# Access Compliance Report

### (Curb Ramps)

| Intersection ID: 24484 | Main Street: SAINTFIELD_PL | Cross Street: SWINFORD_PL | Location: NW           |
| ADA ID: C1C12F4DF41D   | Ramp Type: Perp            | Initial Pass/Fail: Pass   | Overall Compliance: No |

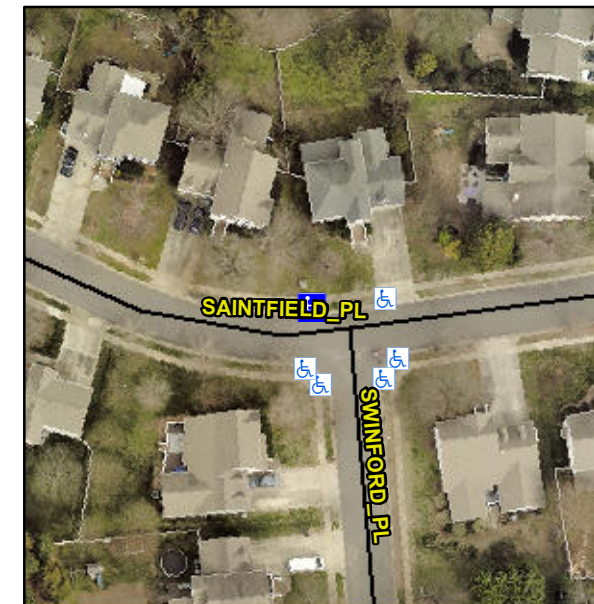
| Compliance | Description           | Data   | Compliance | Description                 | Data |
|------------|-----------------------|--------|------------|-----------------------------|------|
| No         | Landing Length (in)   | 45.0   | No         | DWS Provided?               | No   |
| No         | Landing Slope (%)     | 5.2    | N/A        | DWS Length (in)             | N/A  |
| No         | Gutter Ponding?       | Yes    | No         | Gutter Slope (%)            | 10.6 |

**Remove & Replace Entire Ramp.  
Remove & Replace Gutter.**
